# SAFETY RECALL

# SR17-80A

REVISION A: Table "Other part that may be required" added. It is possible some vehicles require M10 flange screw 5001729 instead of 946440.

## I-START DUAL BATTERY SYSTEM - WRONG CONNECTION OF GROUND CABLES GND11 & GND11A 9700 US/CAN (B13R)

FIGURE 4: PROPER CONNECTION OF GROUND CABLES (it is possible some vehicles require M10 flange screw 5001729 Torque 48 lbf-ft)

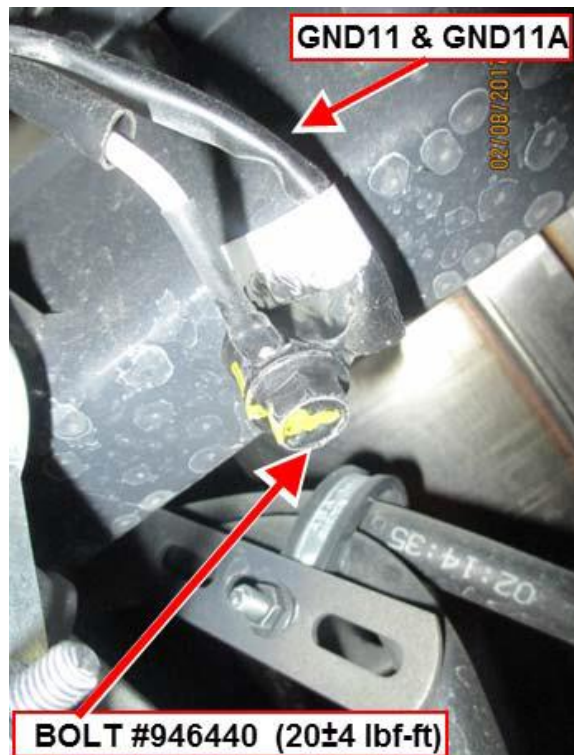
- 3) Make sure that both ground cables (GND11 & GND11A) are connected together on the proper ground connection point (FIGURE 3). If not, perform steps 4 & 5.

FIGURE 3: WRONG CONNECTION OF GROUND CABLES

5) Fasten the ground cable terminals to the connection point using flange screw #946440, torque  $20\pm 4$  lbf-ft (FIGURE 4). **If you need to install the M10 flange screw 5001729, torque 48 lbf-ft.**
